Request for Class II Permissive Change

FCC ID: **YZZGXE5102**

Date: March 21, 2013

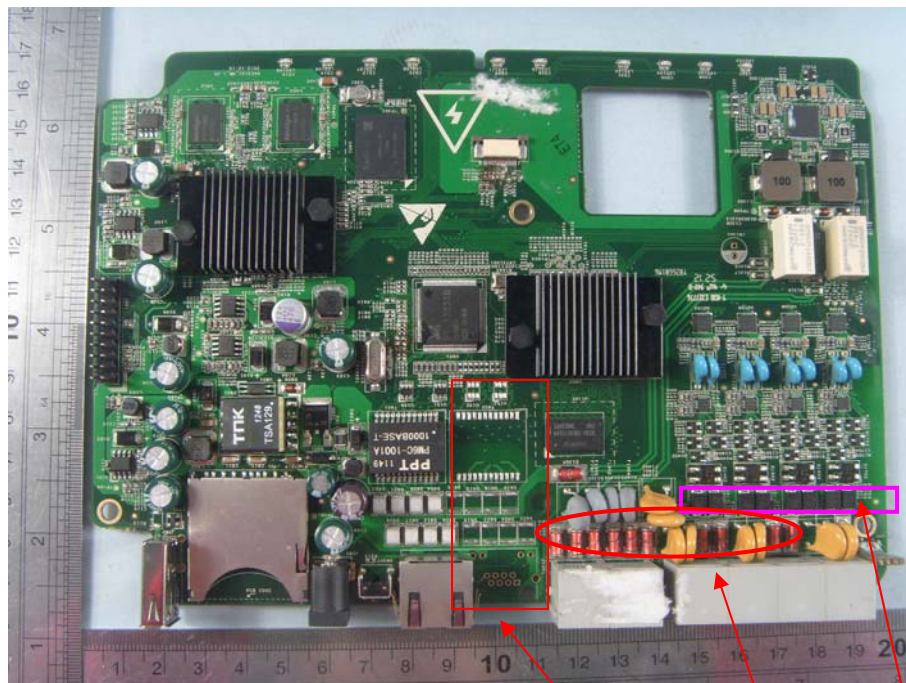
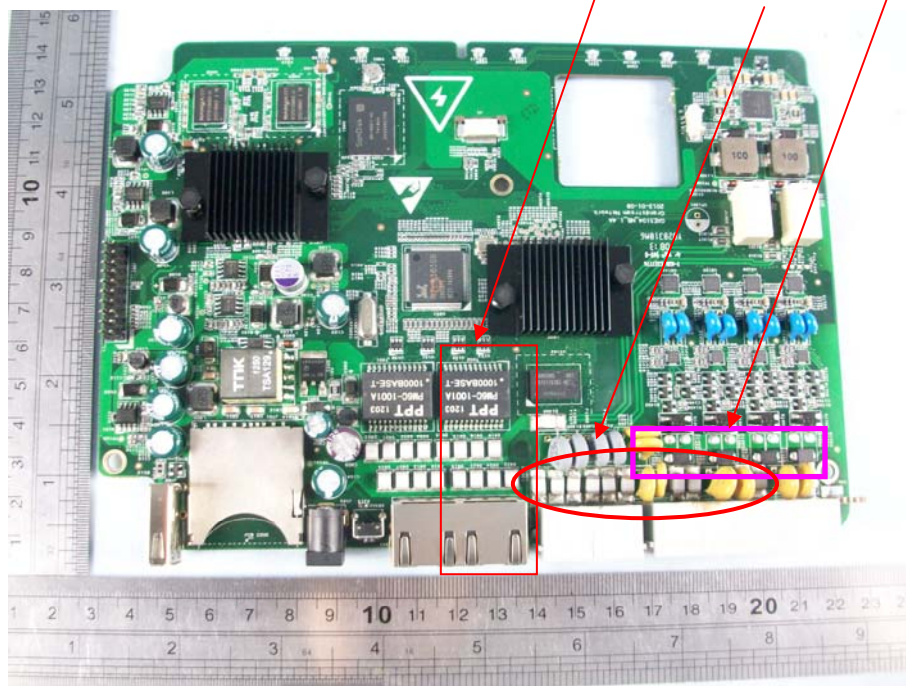
1. Updated model number; changed GXE5104 to UCM6104, GXE5102 to UCM6102;
2. Added an LAN port on original main board reserved location and four surge protectors tube (See Arrow 1);
3. Used four high voltage protectors to replace original eight surge protectors (See Arrow 2).
4. Used ten white surge protectors tube to replace original eleven surge protectors tube (See Arrow 3).
